GW - 25

**GENERAL
CORRESPONDENCE**

OIL CONSERVATION DIVISION

RE: Evaporation Pond Liner Replacement
Discharge Plan GW-25
Monument Gas Plant

NO. OF UNITS REQUIRED THUS		NO-AFE NO.	
WARREN PETROLEUM COMPANY			
A DIVISION OF GULF OIL CORPORATION			
WASTE WATER SYSTEM LAYOUT			
PLANT 118 MONUMENT		LEA, COUNTY, NM.	
DRAWN	HPK	DATE 10/11/85	SCALE NONE
CHECKED	LLJ	DATE 10/11/85	DRAWING NO.
APPR.	PDA	DATE 10/11/85	118-1001-0

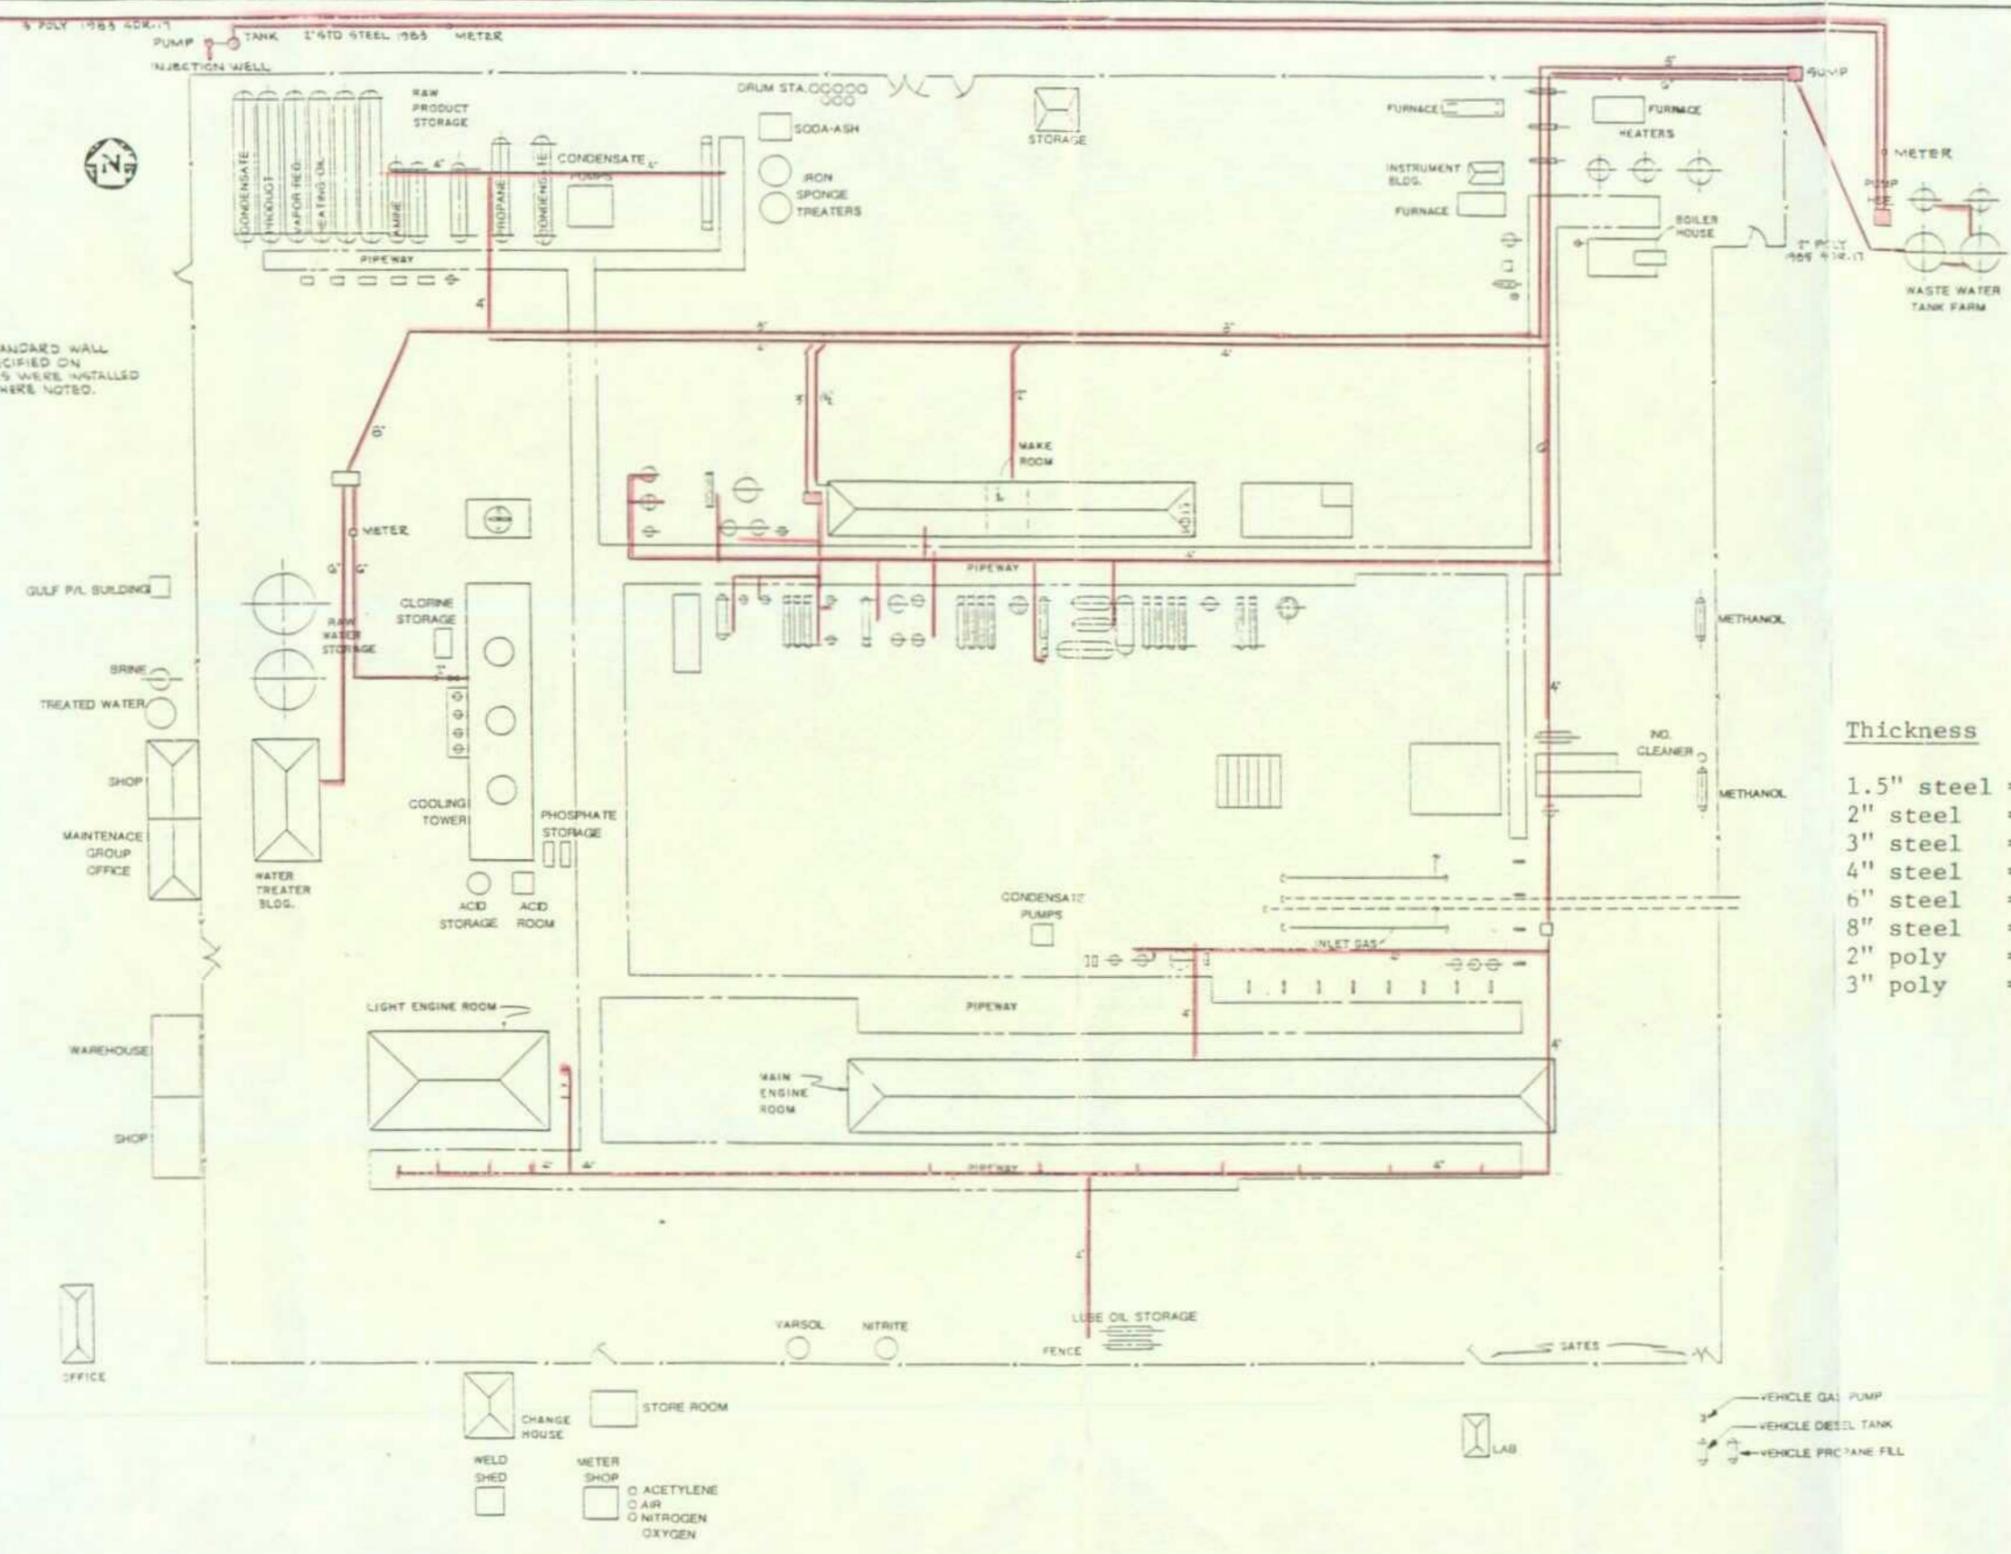
1. Within sixty (60) days of receipt of this letter, the following information concerning any underground wastewater piping for all three plants must be provided:
 - A drawing indicating all underground wastewater pipelines for each plant.

As such, attached please find a drawing for each of the subject plants showing the underground waste water pipelines. The approximate age, material, thickness and pipe diameter are indicated. Steel pipelines are connected by welding; polyethylene lines are joined by butt fusion; PVC pipe is installed using PVC contact cement.
